Resolution to NMP-1 Question SRO #25

SUBJECT: NINE MILE POINT UNIT 1 INITIAL OPERATOR POST WRITTEN
EXAMINATION ACTIVITIES

NRC INITIAL WRITTEN EXAMINATION POST-EXAMINATION ANALYSIS

NRC 2004 UNIT 1 SRO WRITTEN EXAMINATION

Ten Mile Emergency Planning Zone (Plume Exposure Pathway)

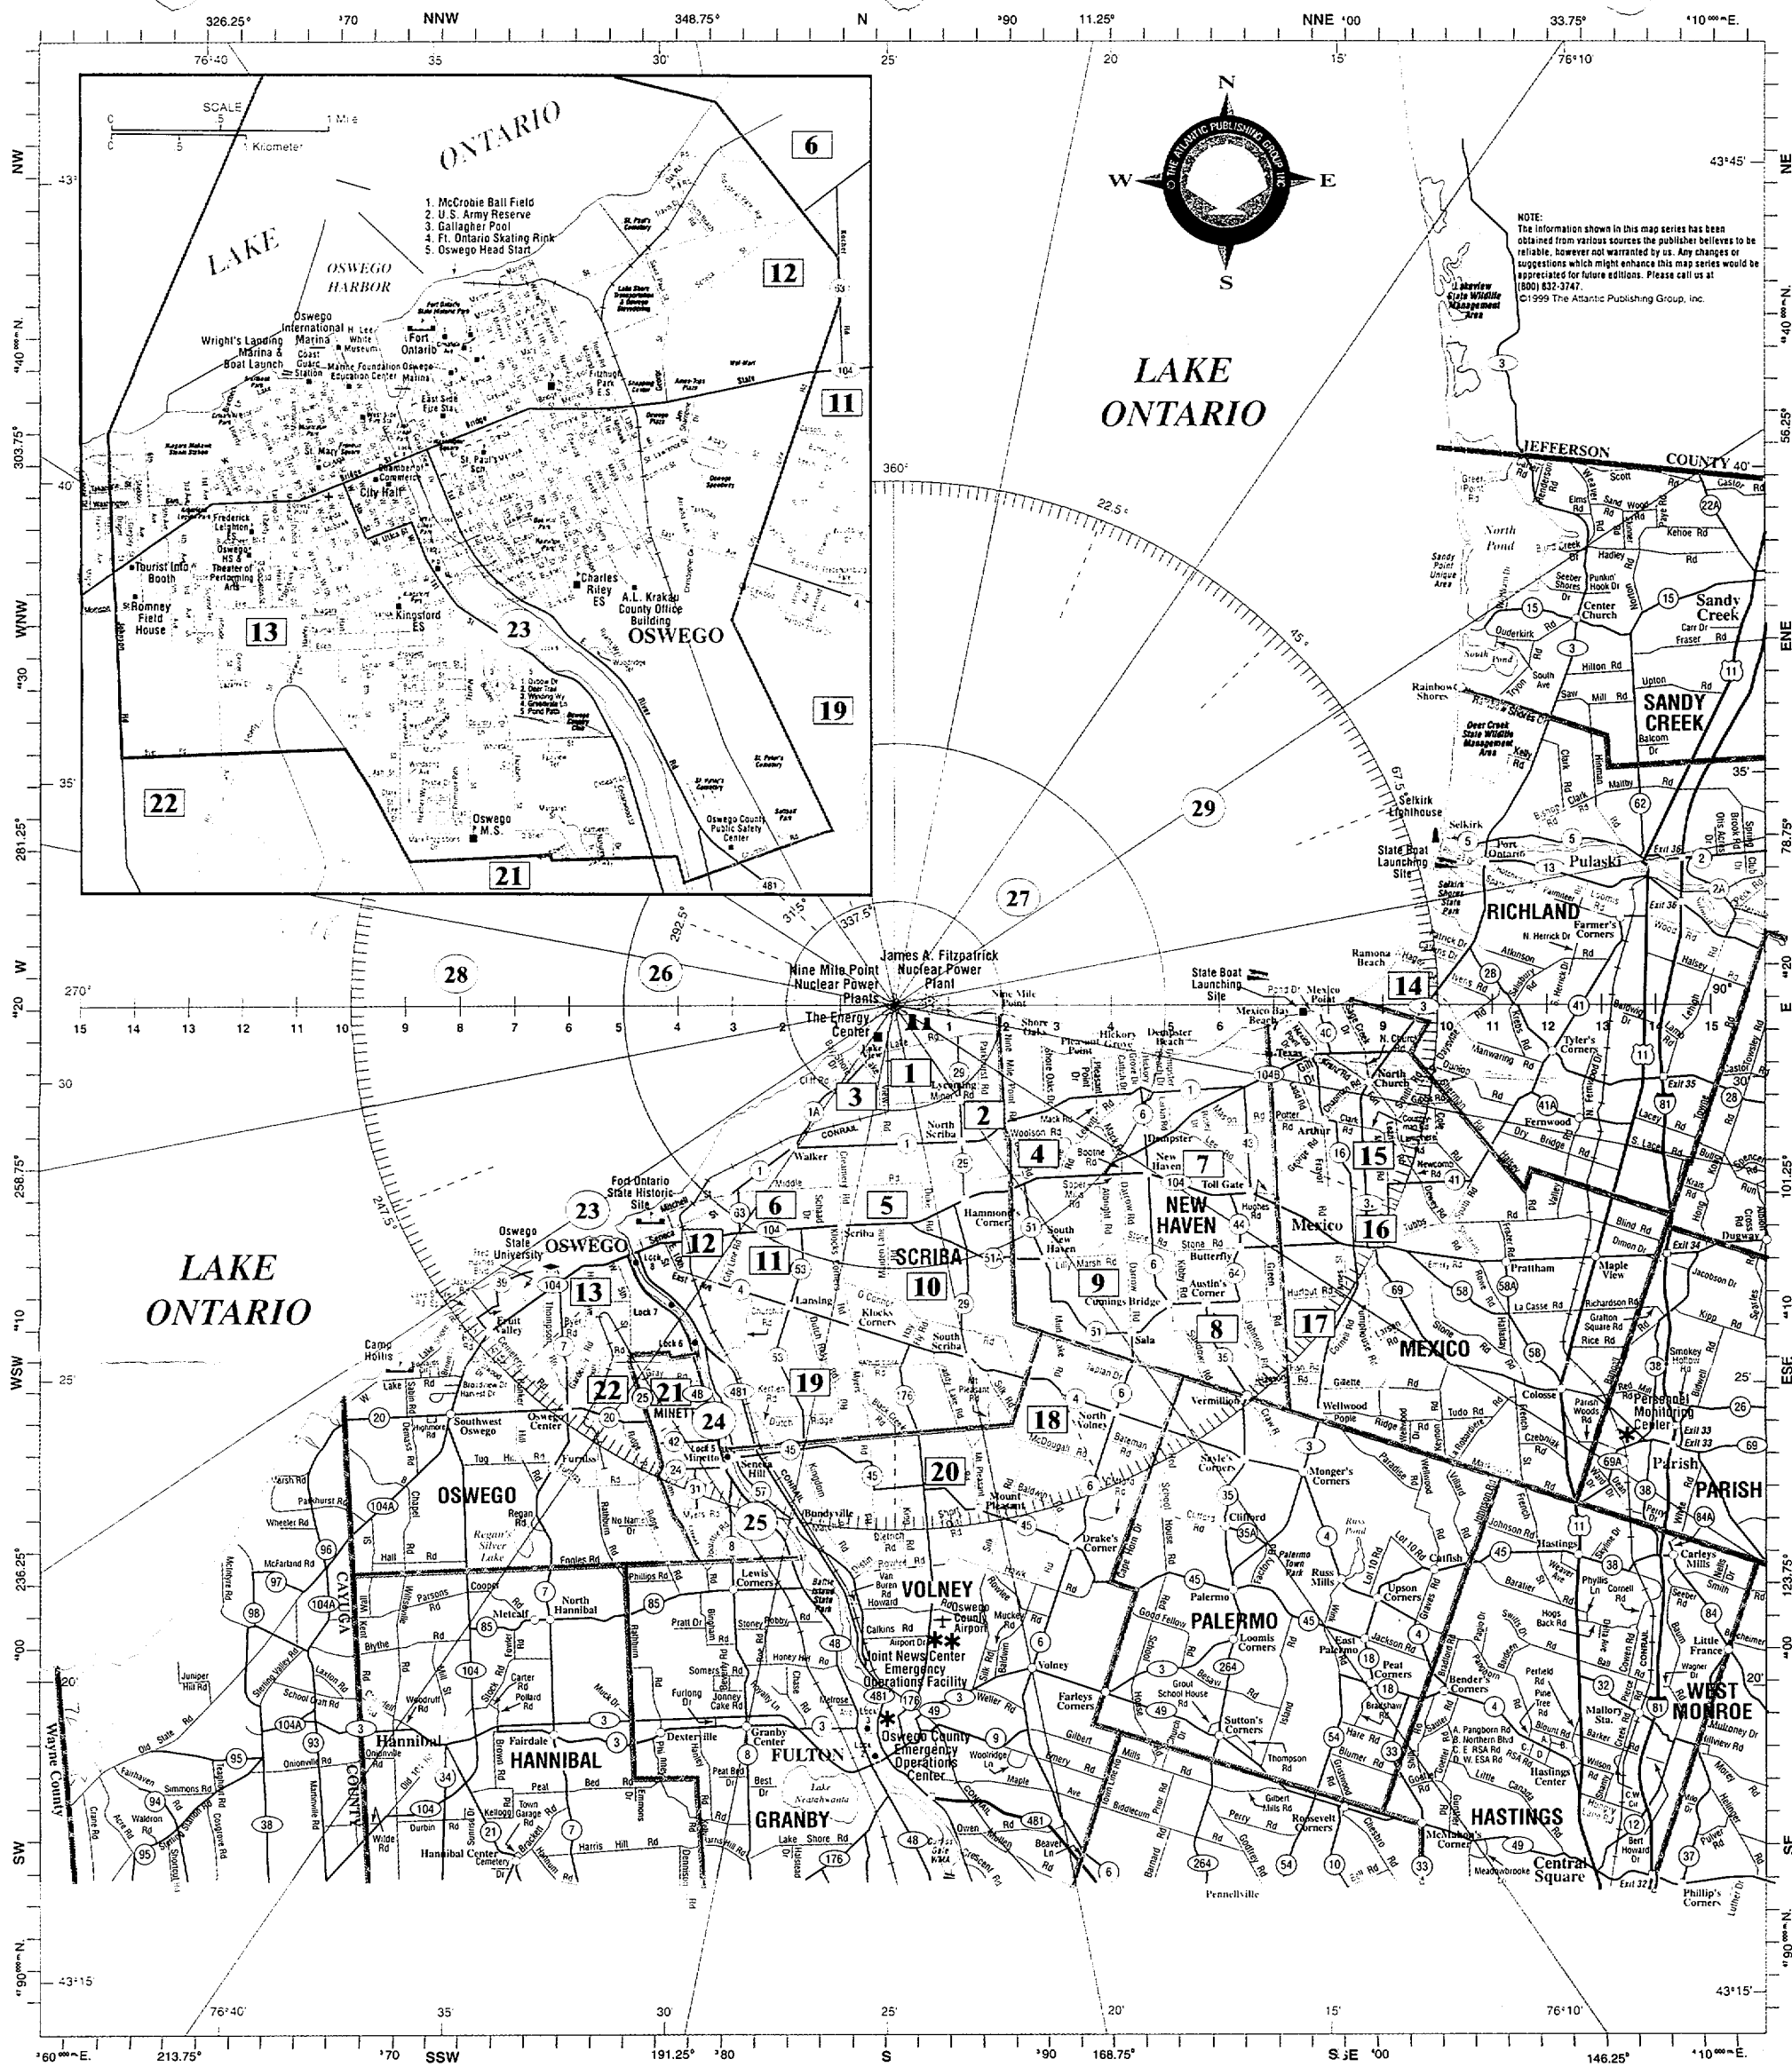
There are multiple assumptions that can be made based on the given conditions. Since evacuation of any ERPA or areas beyond 10 miles is based on the dose projection for that specific area and no areas are stated as being greater than 1 REM then it cannot be assumed there is an area or multiple areas above 1 REM closer to the plant OR farther from the plant. Dose closer to the plant or beyond 10 miles could be in

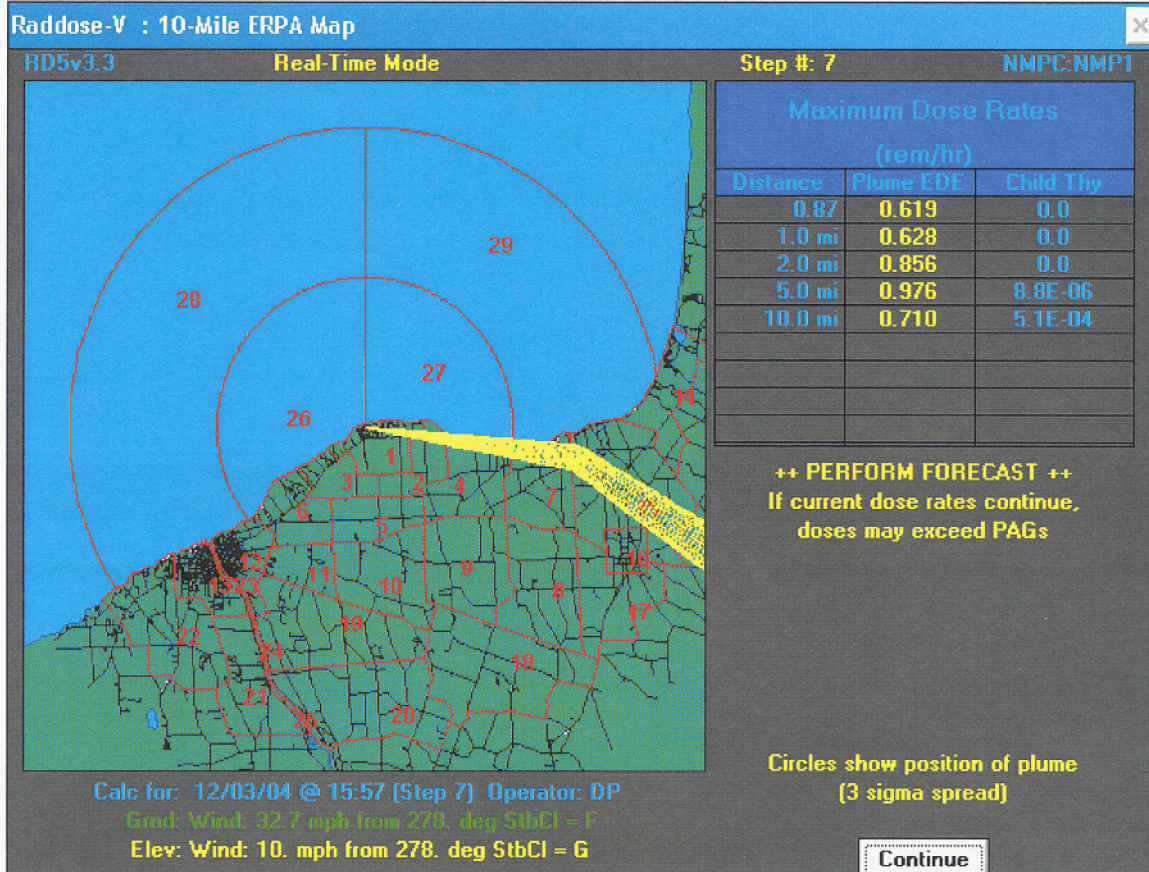
This Dose calculation and following pages shows outward to 10 miles with up to 1 REM (.976) with the greatest Dose at 5 miles from the site and all Dose projections below 1 REM. Note that the wind direction change was included in this case approximately 1 hour into the event.

This dose calculation was made by RADDPOSE software described in EPIP-EPP-08 (see Attachment 5) and maintained in accordance with EPMP-EPP-03 (see step 3.1.4). These doses are based on a LOCA with manually input release data and meteorological data.
